Access Compliance Report Public Rights-of-Way (Curb Ramps)

Main Street: GILBERT_ST Cross Street: RANDOM_DR Location: NE

ADA ID: RPRK210927134232 Ramp Type: Type 6 - Directional 1 Initial Pass/Fail: Pass Overall Compliance: No Severity Score: 0

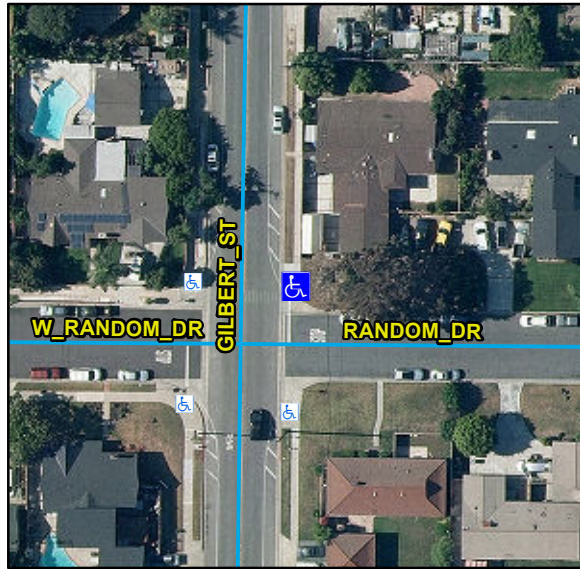
Compliance	Description	Data	Compliance	Description	Data
N/A	Ramp Length (in)	140	N/A	Flare Type LT	
Yes	Ramp Width (in)	78			Sloped
Yes	Ramp Run Slope (%)	2.4	Yes	Flare Slope LT (%)	8.3
Yes	Ramp Cross Slope (%)	0.8	N/A	Flare Traversable LT	Yes
No	Grade Break	No	Yes	Flare Type RT	
N/A	Grade Break Slope (%)	N/A			Curbed2
N/A	Grade Break Cross Slope (%)	N/A	N/A	Flare Slope RT (%)	N/A
	Addl Para Ramp Left?	No	N/A	Flare Traversable RT	N/A
	Addl Para Ramp Right?	No	Yes	DWS Provided	Yes
N/A	Landing Present	Yes	Yes	DWS Contrast	Yes
Yes	Landing Length (in)	69	Yes	DWS Length (in)	67
Yes	Landing Width (in)	48	Yes	DWS Full Width	Yes
Yes	Landing Run Slope (%)	0.9		DWS Offset Type	Single
Yes	Landing Cross Slope (%)	0.8	Yes	DWS Left Offset (in)	0
N/A	Landing Movement Obstructed?	No	N/A	DWS Right Offset (in)	0
	Landing Movement Type	N/A			
N/A	Landing Shared	No			
N/A	Marked Crosswalk 1	No	N/A	Clear Space	Yes
	Crossing 1 Direction	W	N/A	Clear Space To Crosswalk (in)	48

N/A	Marked Crosswalk 1 Width (in)	N/A			
N/A	Ramp Inside Crosswalk 1	N/A			
	Crossing 1 Slope (%)	8.2			
	Crossing 1 Cross Slope (%)	2.9			
Yes	Gutter Ponding	No	Yes	Curb Slope	4.2
Yes	Gutter Lip Height (in)	0		Road Run Slope (%)	4.6
Yes	Gutter Run Slope (%)	1.4		Road Cross Slope (%)	5.8
No	Gutter Cross Slope (%)	4.2		Parallel Ramp Side	Right
Yes	Overall Surface Condition	Acceptable	No	Perp Joint Present	No
	Cross Gutter Present?	Yes		Spandrel Present?	Yes
	Replace Cross Gutter?	No		Replace Spandrel?	No

Remove & Replace Curb Ramp With Two New Directional Ramps or Equivalent. Remove & Replace Gutter.
